REQUEST FOR INFORMATION DATE: January 26, 2017 NO.: RFI-427

Project Name: 15051-Webster University Interdisciplinary Science Building Project No.: 15051

Subject: East retaining wall elevation

3 EAST PROPERTY LINE BRICK WALL PLAN
1/4" = 1'-0"

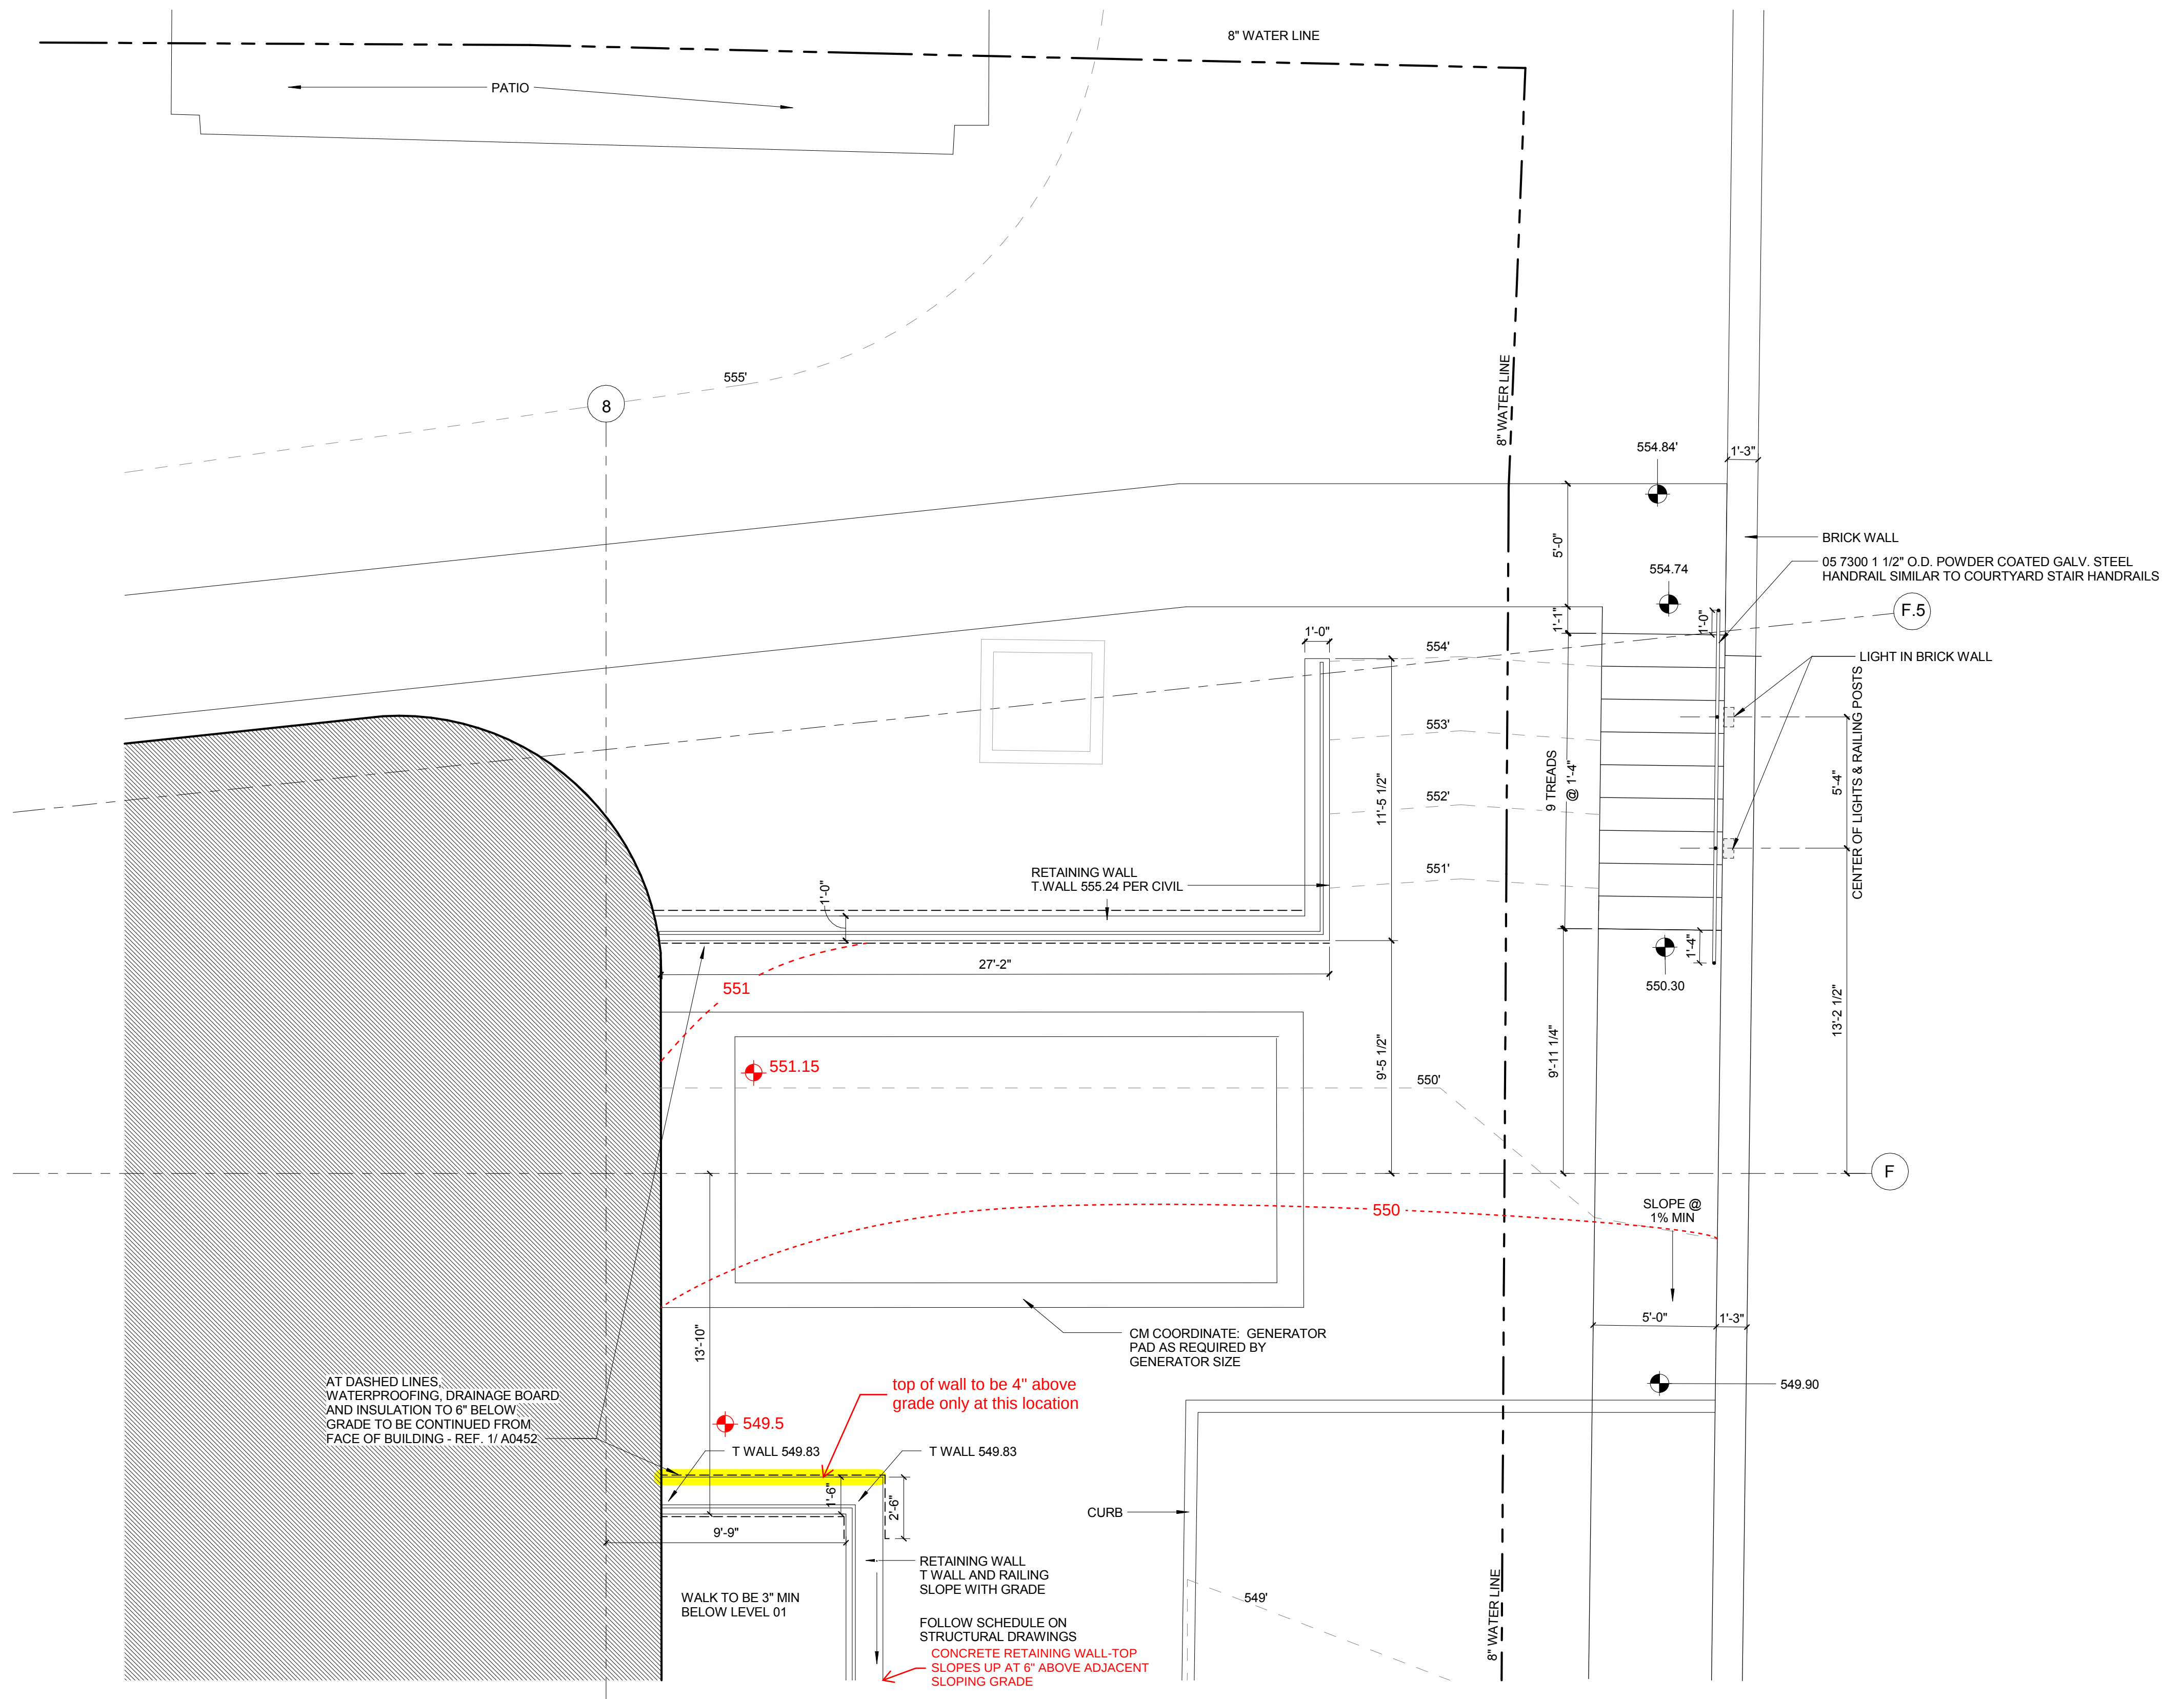
E4/RSE002 has a note that states "T/Wall = 550.5' per A0101.A T/Wall to be 6" above grade" at the north end. Please advise if the entire wall is to raise 6" accordingly or if the other elevations remain as submitted. There are not additional elevations on A0101.A nor are detailed elevations on the site grading plan.

Per A0505, the top of the wall is 549.83 at the north end.
See attached sketch.
